Access Compliance Report

Public Rights-of-Way

(Curb Ramps)

| Intersection ID: N/A | Main Street: S_CALDWELL_ST | Cross Street: E_3RD_ST | Location: SE |

| ADA ID: CAACA783D99E | Ramp Type: Directional1 | Initial Pass/Fail: Fail | Overall Compliance: No |

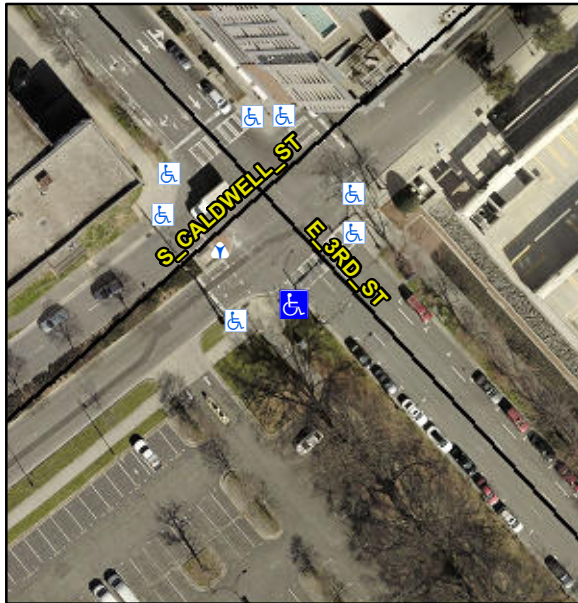
**R304.2.2, R304.2.1, R304.2.2-Perp,
R304.3.2-Para, R304.5.3, R302.7.2,
R304.5.4**

| Compliance | Description | Data | Compliance | Description | Data |
|------------|-----------------------|-------|------------|-----------------------------|------|
| No | Ramp Slope (%) | 10.3 | N/A | Grade Break XSlope (%) | 0.0 |
| No | Landing Length (in) | 0.0 | N/A | DWS Provided? | N/A |
| No | Landing Width (in) | 0.0 | N/A | DWS Contrast? | N/A |
| No | Landing Slope (%) | 0.0 | N/A | DWS Length (in) | N/A |
| No | Landing X Slope (%) | 0.0 | N/A | DWS Full Width? | N/A |
| No | Gutter Lip Ht (in) | 0.0 | No | Gutter X Slope (%) | N/A |

**Remove & Replace Entire Ramp.
Remove & Replace Gutter.**
